NOTICE OF TYPE II DECISION
MINOR LAND PARTITION (MLP) 2010-00001
SONIC PARTITION

FILE NAME:		SONIC PARTITION
CASE NOS:	Minor Land Partition (MLP) Adjustment (VAR)	MLP2010-00001 VAR2010-00004

LOCATION: 15300 SW Pacific Highway; Washington County Tax Map 2S110DB, Tax Lot 500.

ABANDONED BUILDINGS
PLAT PARTITION FOR SONIC DRIVE-IN AND FUTURE TENANT

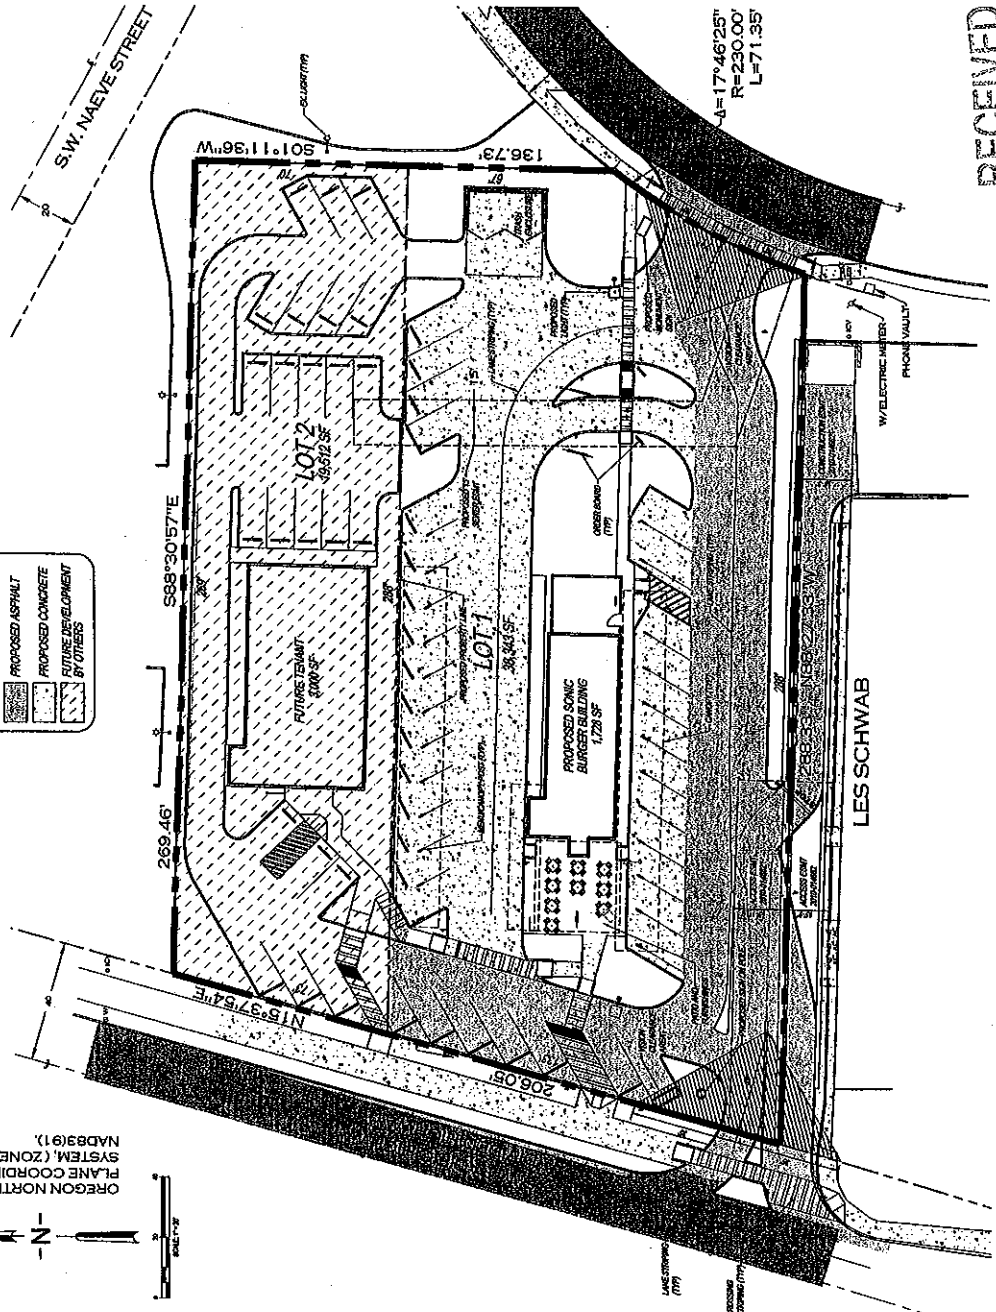
There is one existing free-standing sign on site that was used for the previous nursery business. The applicant did not address the removal of this sign, but the sign is also not shown on the preliminary plat/site plan. A condition of approval will ensure the removal of the existing sign prior to issuance of permits for the proposed signage.

The minimum lot width required for the C-G zoning district is 50 feet. Lot 1 has an average parcel width of 129 feet, while Parcel 2 has an average width of 70 feet. This information was gathered from the scaled site plan because the applicant did not give specific dimensions within the narrative. This standard has been met.

Previously approved access drives on Lot 1 will provide public street access for Lot 2. The applicant has proposed an ingress, egress, circulation easement on Lot 1 for the benefit of Lot 2 via the final plat, but that plan is not to scale. A condition of approval under the Land Partition section of this decision ensures this requirement will be satisfied.

The applicant proposes a 15-foot wide sanitary sewer easement to be provided to the City of Tigard over the public main running from Royalty Parkway across Lot 1 to serve Lot 2. The easement is shown on the preliminary plat. A condition of approval will ensure the easement is included on the final plat.

Public sewer has been extended into the site. The preliminary plat shows a 15-foot wide sanitary sewer easement. A condition of approval will ensure this requirement is met.

CONDITION: Prior to the issuance of sign permits, the applicant shall remove all existing signage, including the freestanding sign along SW Pacific Highway.

CONDITION: Ensure that joint access agreements between Sonic and Les Schwab, and between Lots and 2 are established, recorded, and recorded documents referenced on the final plat.

CONDITION: The applicant shall show a 15-foot public sanitary sewer easement on the final plat for the public line located on Lot 1.
